Riley Purgatory Bluff Creek Watershed District Permit Application Review

Permit No: 2022-010

Project: Suite Living of Eden Prairie – The applicant proposes the construction of a new assisted living facility, parking lot, and landscaping. Two subsurface stormwater filtration facilities and a rainwater harvesting system for irrigation will provide water quality treatment, rate control, and volume abstraction.

Reviewer: Leslie DellAngelo, PE, and Scott Sobiech, PE, Barr Engineering

WETLAND 1 PROPOSED

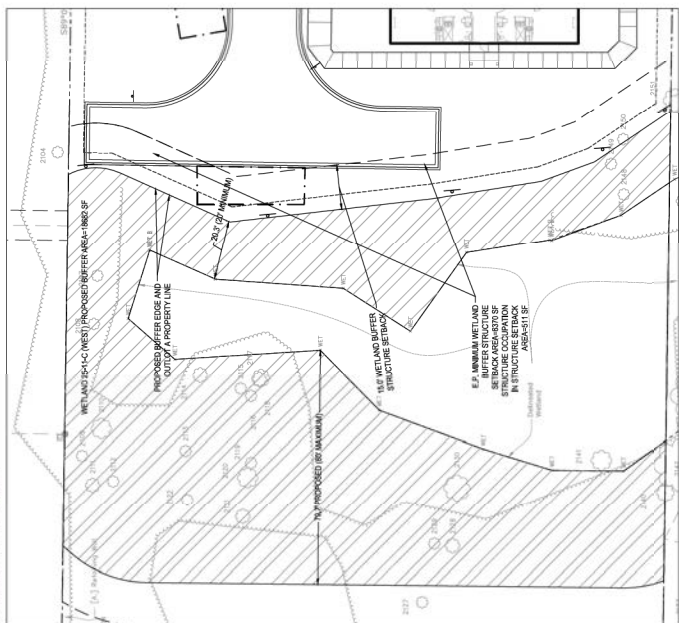
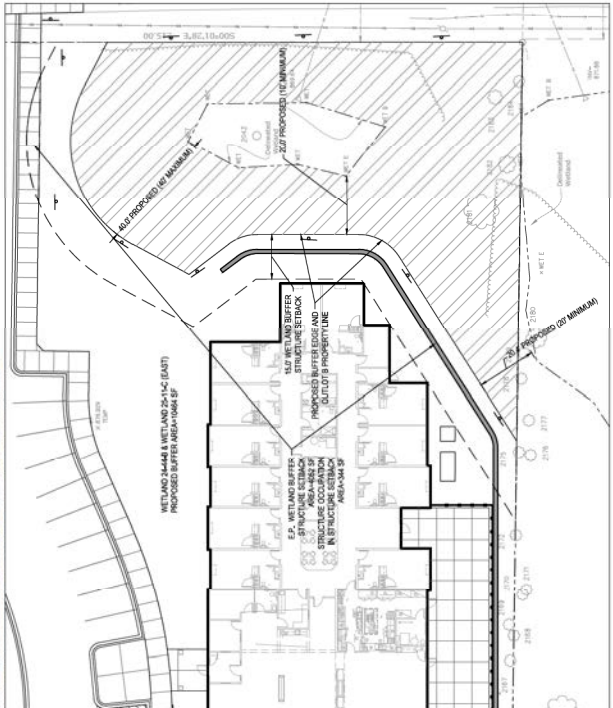
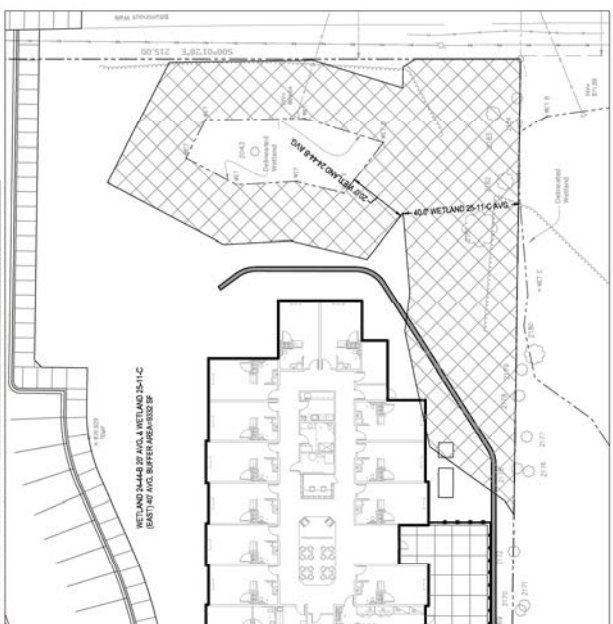
- D1. Additional buffer signs must be shown on the drawings to delineate the westernmost buffer for Wetland 1.
- D2. Buffer areas and maintenance requirements must be documented in a declaration recorded after review and approval by RPBCWD in accordance with Rule D, Subsection 3.4.
